GLOBAL SAFETY FIELD INVESTIGATIONS
DCS6060
URGENT - DISTRIBUTE IMMEDIATELY

Subject: N222359350 - Service Update
Transmission Fluid Potential Leak at the Pipe to Accumulator
– US Only

Models: 2022 Chevrolet Equinox
Equipped with a Engine-Gas, 4 CYL, L4, 1.5L, Transmission-Auto 6
SPD (RPO LYX, MNH)

N222359350 Transmission Fluid Potential Leak at the Pipe to Accumulator

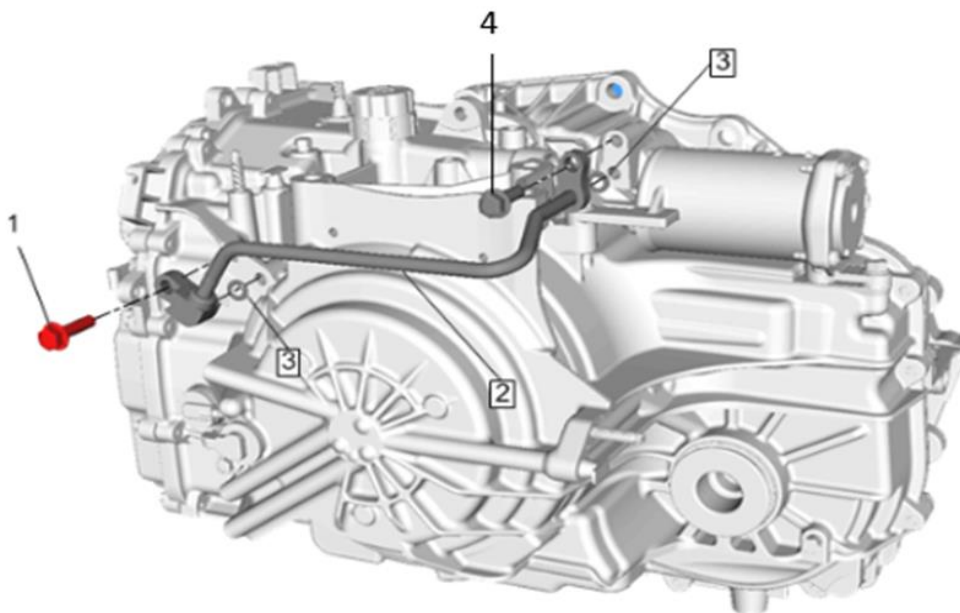
Condition	Certain 2022 model year Chevrolet Equinox vehicles equipped with a gas engine and six-speed transmission, may have a slow dripping leak between the transmission case cover and the pipe to the accumulator due to insufficient pressure on the slimline seal washer at the case. This is caused by excess friction in the tapped hole.
Correction	Dealers are to inspect for a leak and verify torque to upper end of specification.

3. Tighten the bolt indicated by (1) to 25 N-m (18 lb ft).
4. Reinstall the Front Wheelhouse Liner – Left Side. Refer to *Front Wheelhouse Liner Replacement - Left Side* replacement in SI.
5. Reinstall the battery tray. Refer to *Battery Tray Replacement* in SI.
